PIC24FJ128GB204 Family Silicon Errata and Data Sheet Clarification

The PIC24FJ128GB204 family devices that you have received conform functionally to the current Device Data Sheet (DS30005009C), except for the anomalies described in this document.

Data Sheet Clarifications

FIGURE 33-14: I²C BUS DATA TIMING CHARACTERISTICS (MASTER MODE)

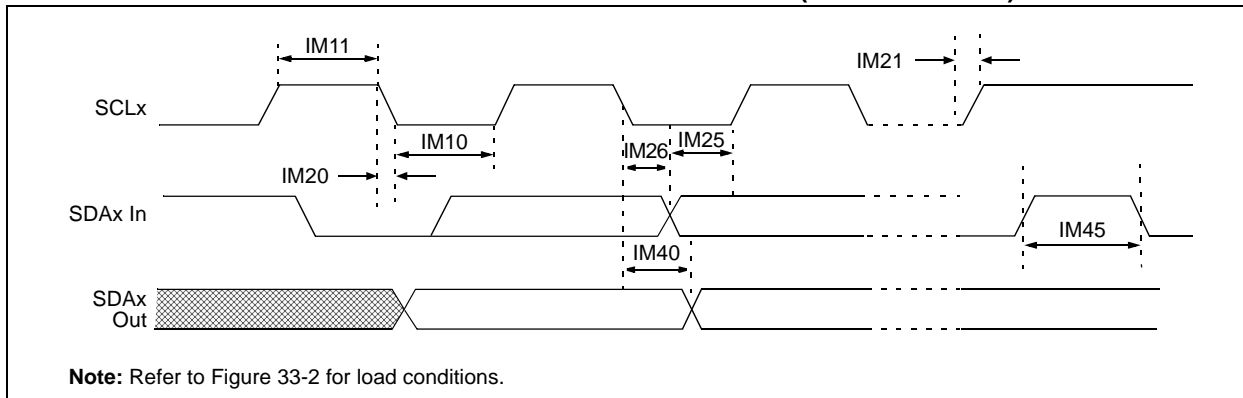
Figure 33-14 and Figure 33-16 are modified as shown in the figures below.
